PLANNING COMMISSION REGULAR DOCKET TUESDAY, February 12, 2019 at 5:30 P.M. CITY COUNCIL CHAMBERS

PLANNING COMMISSION REGULAR DOCKET
January 8, 2019 – 5:30 P.M.
CITY COUNCIL CHAMBERS
NDS Conference Room

CITY OF CHARLOTTESVILLE
DEPARTMENT OF NEIGHBORHOOD DEVELOPMENT SERVICES
STAFF REPORT TO THE ENTRANCE CORRIDOR REVIEW BOARD (ERB)

ENTRANCE CORRIDOR (EC)
Request to Amend the May 8, 2018 Certificate of Appropriateness

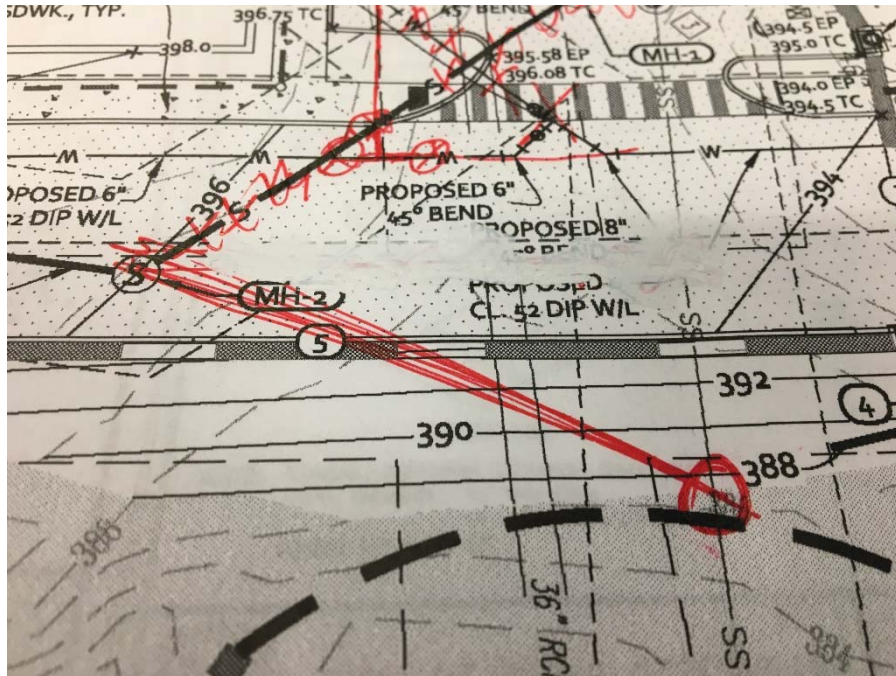
16. **Repeat Comment:** The sanitary sewer flows on the cover sheet appear to be acceptable. Please provide the phase one and overall sewer flow calculations in a P.E. sealed letter (PDF is fine) such that the City can request flow acceptance from RWSA.
17. On sheet 6, the new sanitary sewer alignment for the sewer connections cannot be approved. Please show a new manhole being added approximately 55 feet SE of MH-EX-3. Proposed MH-2 should connect directly to this new MH. This new MH should be less than 15-feet deep as it will help reduce the amount of sanitary sewer main that must be replaced. We expect this new sewer line to connect at the invert (no drop) and cross under the existing storm 36-inch RCP storm sewer and proposed pipe 5. Below is a photo of this sketched on the plan:

PROJECT #: 18082.0
 FIELD BY: TSC-JSP-OSL-NJB
 FIELD DATES: 09-18 TO 12-18
 DRAWN BY: TSC
SHEET 9 OF 15

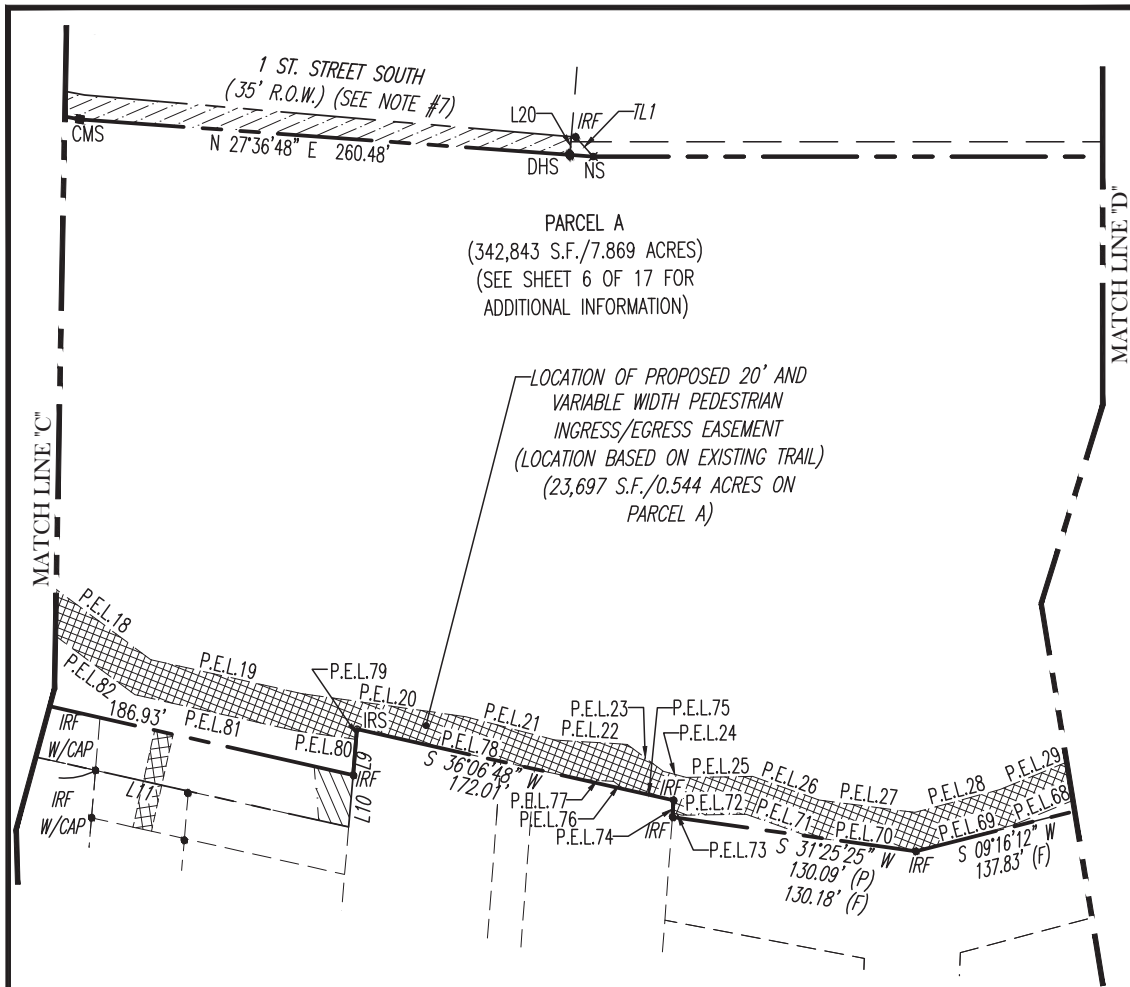
15. A note with the reference meridian indicates Note #2 is on Sheet 1 of 17, however Note #2 is located on Sheet 2 of 15. Please revise.

PROJECT #: 18082.0
 FIELD BY:
 TSC-JSP-OSL-NJB
 FIELD DATES:
 09-18 TO 12-18
 DRAWN BY: TSC
SHEET
10 OF 15

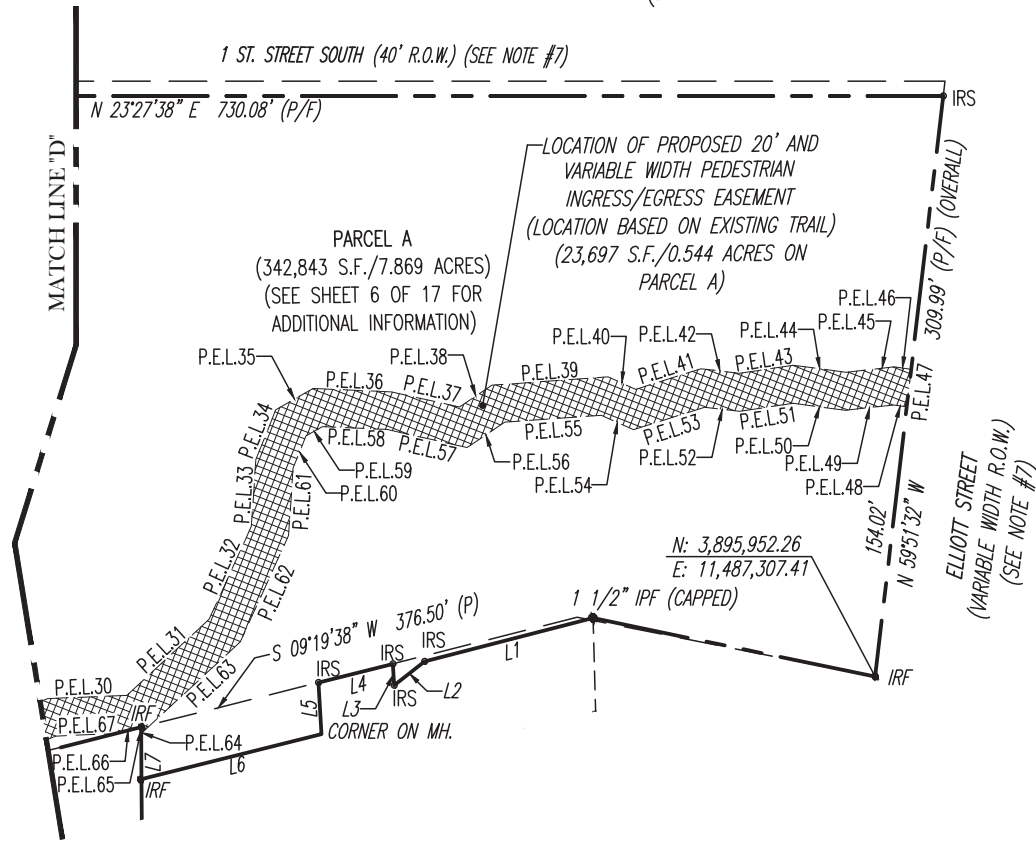
17. A note with the reference meridian indicates Note #2 is on Sheet 1 of 17, however Note #2 is located on Sheet 2 of 15. Please revise.

PROJECT #: 18082.0
FIELD BY:
TSC-JSP-OSL-NJB
FIELD DATES:
09-18 TO 12-18
DRAWN BY: TSC
SHEET
14 OF 15

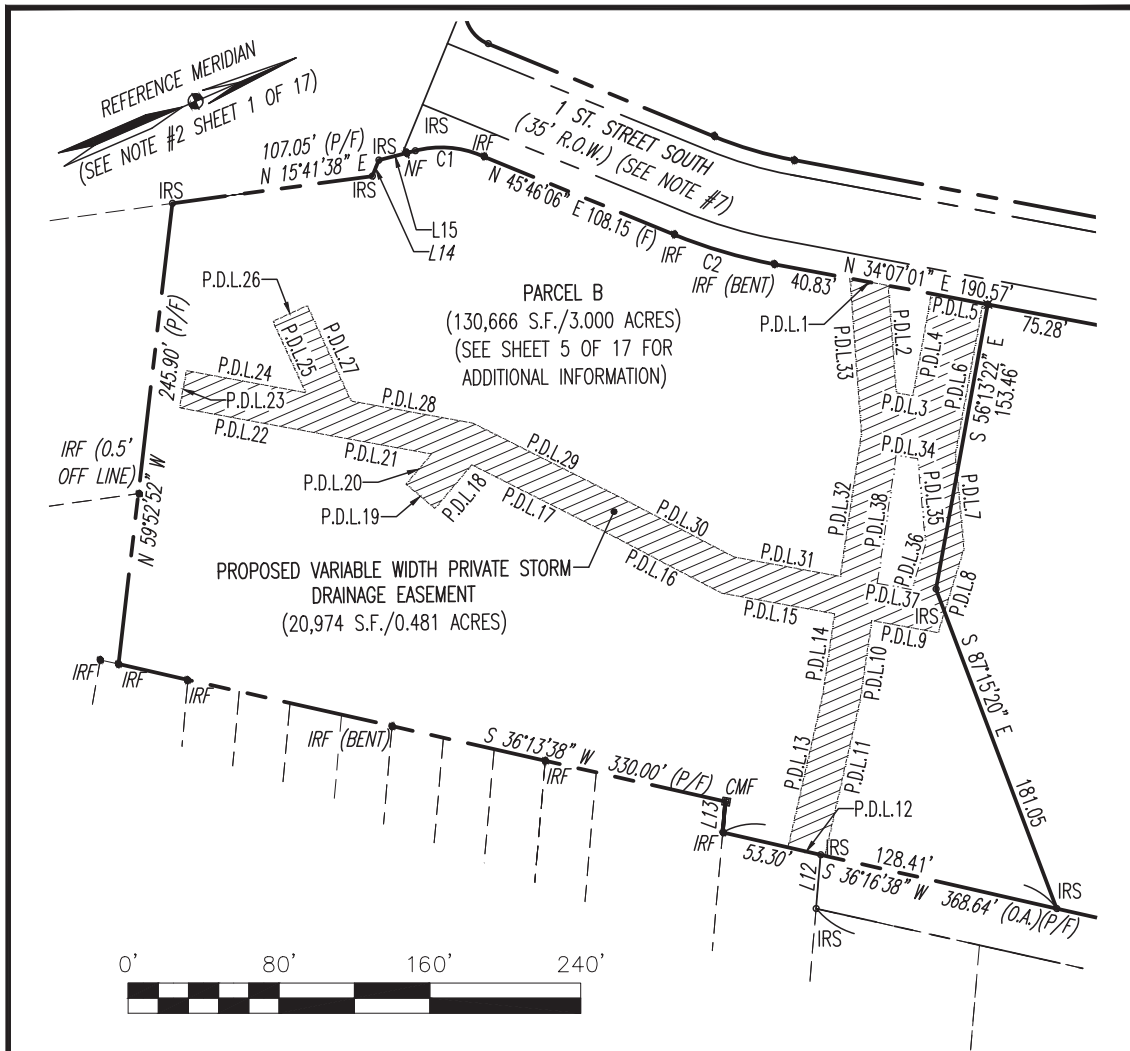
20. A note with the reference meridian indicates Note #2 is on Sheet 1 of 17, however Note #2 is located on Sheet 2 of 15. Please revise.

PROJECT #: 18082.0
 FIELD BY:
 TSC-JSP-OSL-NJB
 FIELD DATES:
 09-18 TO 12-18
 DRAWN BY: TSC
SHEET
15 OF 15

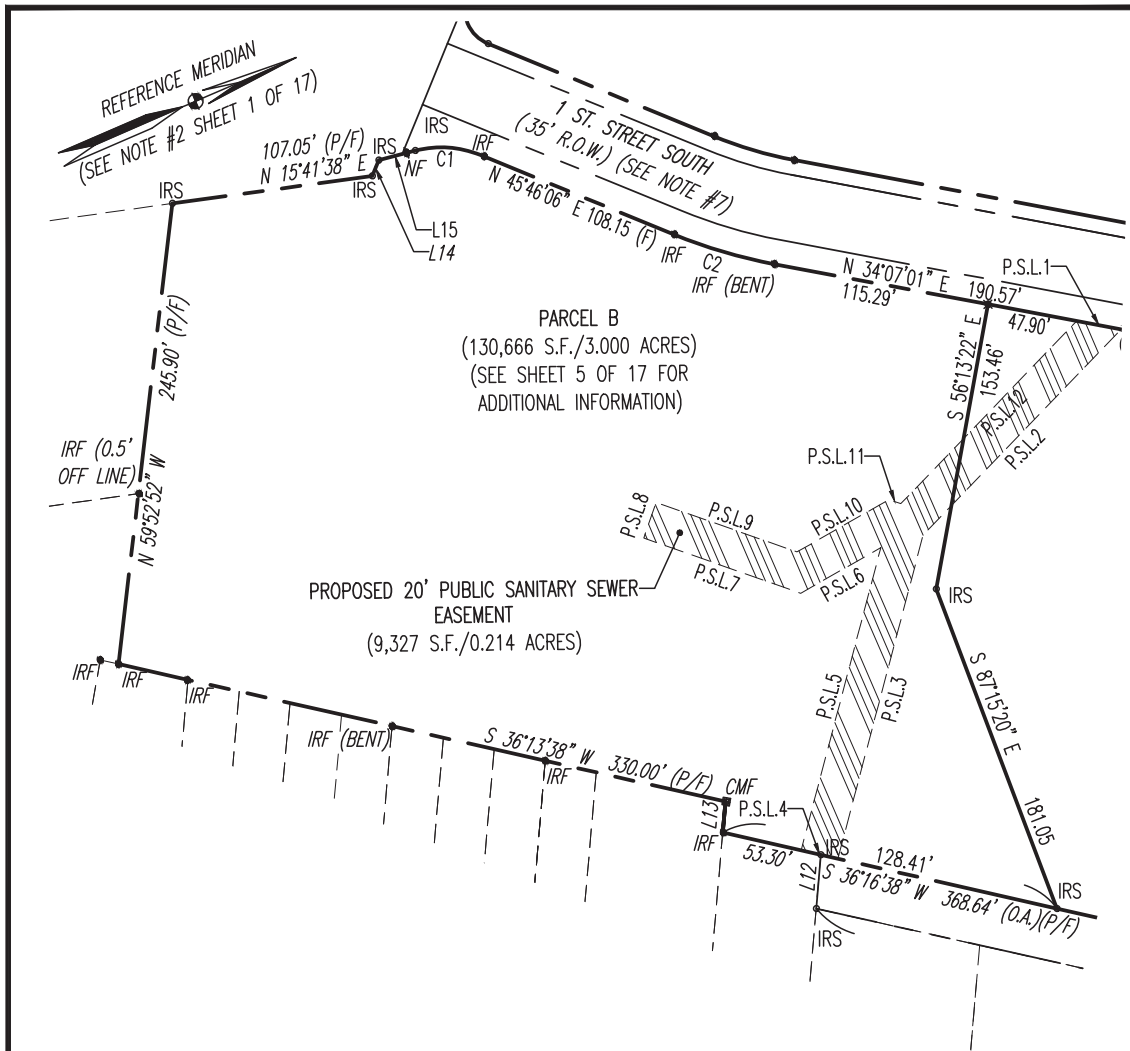
21. A note with the reference meridian indicates Note #2 is on Sheet 1 of 17, however Note #2 is located on Sheet 2 of 15. Please revise.
